Subject Change Order No. 1 - Strawn Construction - Castlemont Intensive Support Site Project

PRELIMINARY CHANGE ORDER NO. 1

Construction Change Document: CCD #10.1

TITLE: Add new ceiling, lighting and Misc Improvements to Library

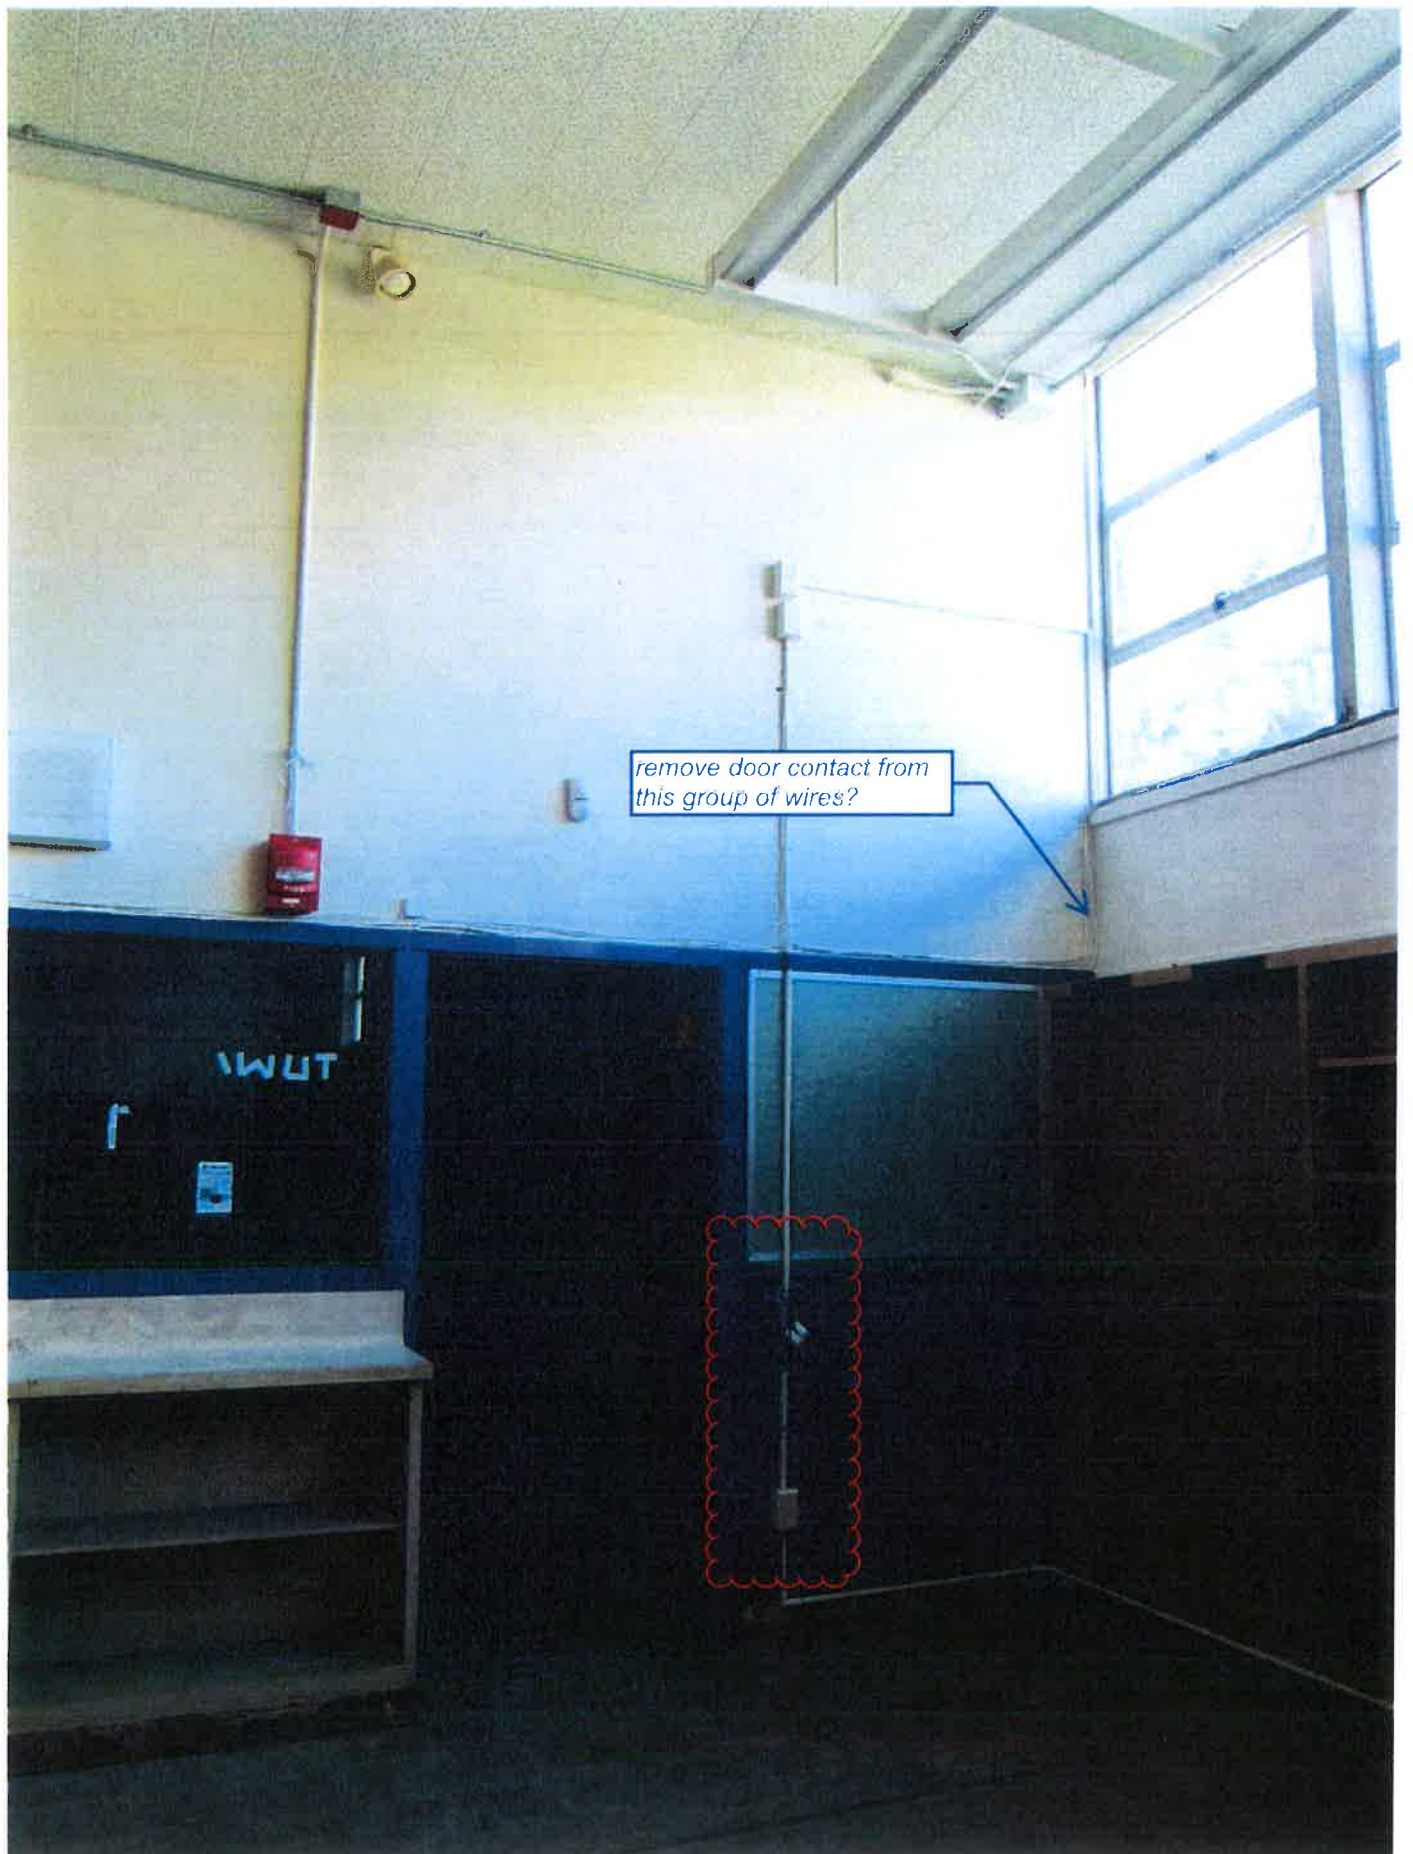
see the image below – the white part I poked into indicates the gyp board I was talking about.

From observation, it is not clear that what is behind they gyp is damaged. Can you clarify your direction?

Mike – just to follow-up on our conversation on Sat - so the SCA report in CCD 06 stands that the material should be removed to the studs.

Please cut out to the studs, disinfect the studs and add the anabec treatment.
